RE: St. Laurent Lagoon Assessment
Notice of Alteration - Sandy Bar Road Wastewater Treatment Facility

This Notice of Alteration letter and enclosed \$500 application fee are being submitted to Manitoba Conservation and Water Stewardship (MCWS) to request an amendment to the Clean Environment Commission Order 744 (CEC744) for the Manitoba Housing Authority Sandy Bar Road Wastewater Treatment Facility (commonly referred to as the St. Laurent Lagoon, See Figure 1 Site Plan). This Notice of Alteration is being submitted to request an amendment respecting the discharge practices and procedures in response to the MCWS letter, dated February 26, 2015. Details of how the discharge operations vary from the license requirements and associated effects are given in the following sections, to obtain formal authorization from MCWS and for inclusion in the Client File No. 318.15.

LAGOON ASSESSMENT
ST. LAURENT, MANITOBA

SITE PLAN

FIGURE 01

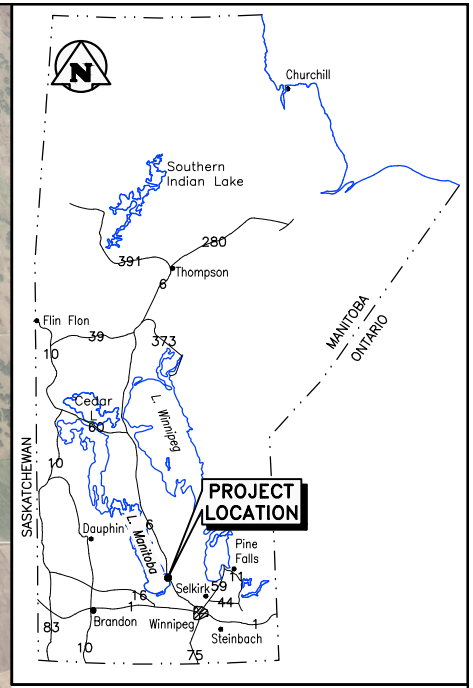
It is proposed that the area between the flood protection dike and the existing cells be used as a holding cell for treated effluent before surface release occurs. This can be accomplished by installing a new interconnecting valve on the Secondary Cell of the lagoon and converting the culvert through the flood protection dike to a valve. The location of the new valves (as shown on Figure 1) will be documented and marked within the facility. By introducing a holding cell, the capacity of the facility will be increased approximate total capacity of 52,000 m³.

In consideration of the long-term use of the facility, Manitoba Housing Authority has proposed a relocation of the access road. Therefore, the existing road will not be repaired, but a new road will be constructed to suitable conditions. The proposed road alignment is shown on Figure 1.

The facility is surrounded by a chain link fence with a single access gate to the east of the Primary Cell. The fence is intended to discourage trespassing and prevent wildlife from entering the facility. As identified in the February 26, 2015 letter from MCWS, sections of the fence are in poor condition and warrant repair. Manitoba Housing will complete these repairs, and also relocate the access gate to the location of the new access road.

The February 26, 2015 letter from MCWS indicated that the interconnecting valve between the Primary Cell and Secondary Cell needed to be checked for functionality. It has been confirmed that this valve is not currently operational and the other valve could not be located. Both of these valves will be replaced, and the locations will be documented and marked within the facility. A third valve will be adapted into the current culvert to allow discharge from the holding cell to the marsh area.
